City Planning Department

Memo

To: Cranston City Plan Commission
From: Joshua Berry, AICP - Senior Planner
Date: December 3, 2021
Re: **Ordinance #9-21-01** In Amendment of the 2010 Comprehensive Plan for the City of Cranston, as Amended 2012 (**777 Cranston Street**); *AND*

Ordinance #9-21-02 In Amendment of Chapter 17 of the Code of the City of Cranston, 2005, Entitled "Zoning" (**Change of Zone – 777 Cranston Street**)

FREESTANDING SIGN DETAIL

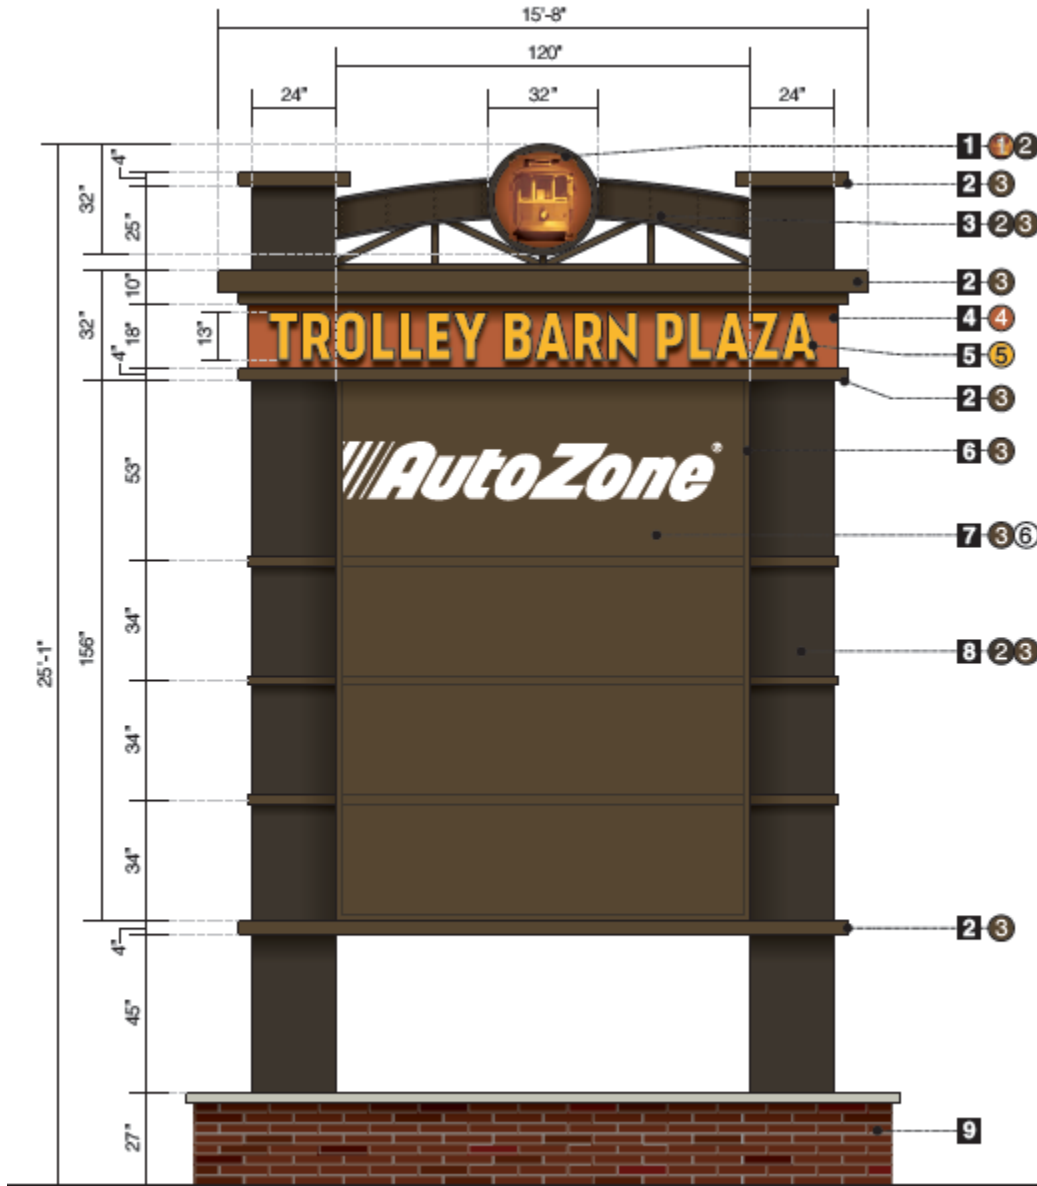
(please note these are outdated as the sign has been revised from 25' to 20' tall)

7. The applicant has worked with staff and has incorporated comments from the Plan Commission in the design of the proposed free-standing sign. The sign pays homage to the history of the site and unifies the signage along the street instead of proposing freestanding signs for each individual use;

WALL SIGN DETAIL & RENDERING

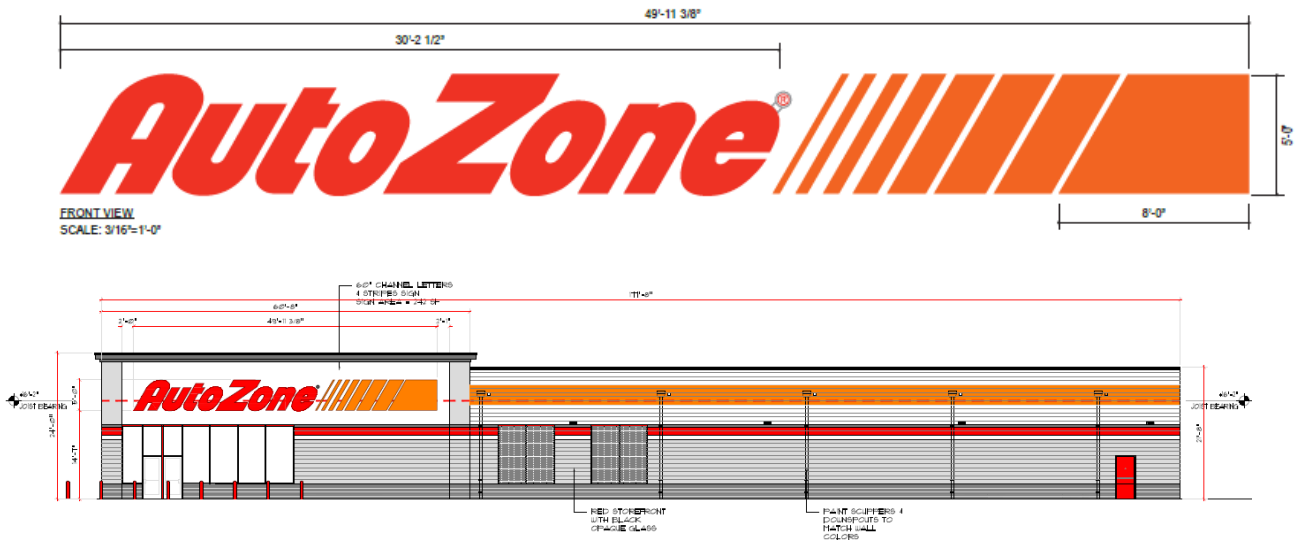
1. Ordinance #9-21-02 Condition #2 requests 250 ft² of wall signage for the AutoZone. This area is **833% greater than the 30 ft² permitted under C-5**. The applicant provided sign details and a scaled perspective rendering on the afternoon of 12/3/21, long after the corresponded deadline, not leaving staff any time to review. The applicant had previously indicated that they *may* request to withdraw this condition and address the signage through a separate application to the Zoning Board of Review, but has instead chosen to move forward with the condition as proposed. **Based on the lack of sufficient time to review materials, and believing that wall signage is too large to meet the intent of zoning, staff opposes Ordinance #9-21-02 Condition #2;**

Due to the finding that Condition #2 regarding 250 ft² of wall signage is not consistent with the purposes of zoning, staff recommends that the Plan Commission send a **negative recommendation** on Ordinance #9-21-02 to the City Council.

It should be noted that if the applicant were to withdraw condition #2, staff would recommend that the Plan Commission forward a positive recommendation on Ordinance #9-21-02 to the City Council.
